1. Response to general comments from Reviewer R2

The "BARRA v1.0: Kilometre-scale downscaling of an Australian regional atmospheric reanalysis over four midlatitude domains" paper evaluates the performance of high resolution downscaled regional reanalysis datasets over four Australian cities, collectively BARRA-C, derived from the coarser resolution continent-spanning BARRA-R dataset.

2. Response to specific questions from Reviewer R2

Figure S9: (top) land mask or fraction of the various models centred at the Hobart Airport (red crosses), Tasmania, (middle) their orography, and (bottom) domain surface cover types for BARRAs.

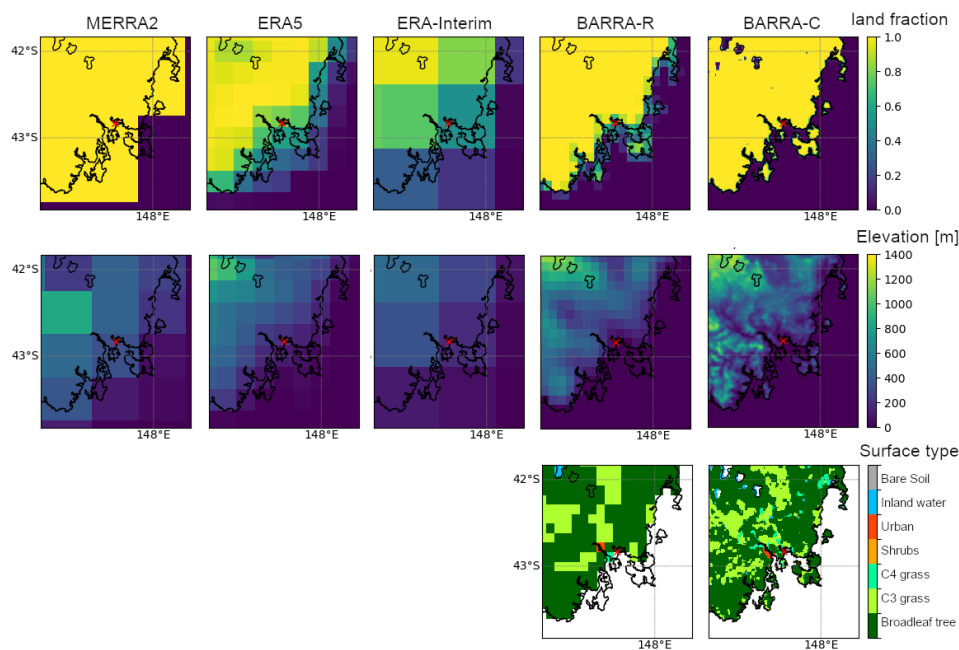
18. Section 3.2 As part of the discussion comparing BARRA against AWAP observations, the authors begin to discuss the impact that choosing the closest model grid cell to an observation location can have on validation results, especially if the closest model grid point is of a different land use type or not even a land point at all. At this point, it would be good to see in a bit more detail about the datasets used to define these characteristics and, at least for one observation site, how different these land cover fractions or land use types are across the BARRA models. Can this assertion be backed up? Could be added to the Supplemental material.

In view of the comment R1#8 from the first reviewer on added value analysis, we have expanded this local-scale analysis of extreme temperature to become a part of this analysis in Sec. 3.6. In particular, we expand this with the added value analysis (see reply to comment R1#8) to look at warm extremes, cold extremes and wet extremes across the domains, not limiting to few selected locations. We move Figure 5 and the local-scale analysis to the Supplement, where we can add illustrations of the differences in land fractions, topography and surface cover types for Tasmania as an example to illustrate differences between the models. The Supplement notes,

"The closest model grid cells are selected, and due to differences in spatial resolution, not all models treat these cells as land points, and even as a land point, they are treated with different land fractions. These affects how representative they are simulating temperature seen at the local scale. Figure S9 illustrates this for Tasmania, where the associated grid cell land fraction varies between

0.55 (BARRA-C) to 0.8 (ERA5) and the elevation varies between around 2 m (BARRA-C) to about 200 m (ERA reanalyses).
